Product Change Notification

1. ECR #: 25-38569-1
Notification #: 803

2. Date of Announcement: November 04, 2025

- BCS-1XX-XXX-D-HE-XXX - null
- SSM-1XX-XXX-DH-XX-XX-XX-X-XX - null

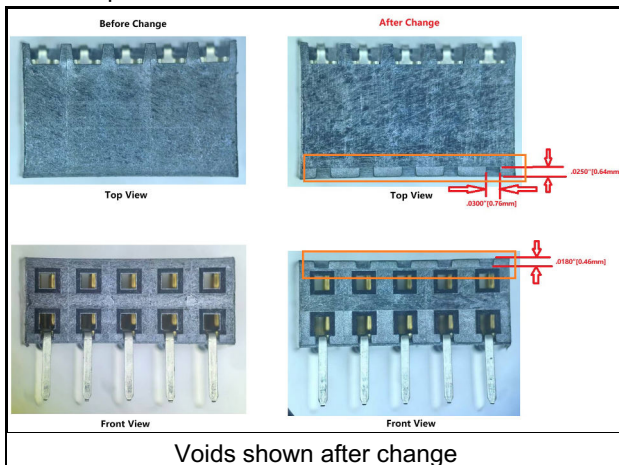
Add voids across the top front area of body, void size is about 0.76 x 0.64 x 0.46 mm.

Add voids (about 0.76 x 0.64 x 0.46 mm) to improve resin reflow and body manufacturing stability, no functional concern. This will be a rolling change.

- Form - This will be an appearance difference.
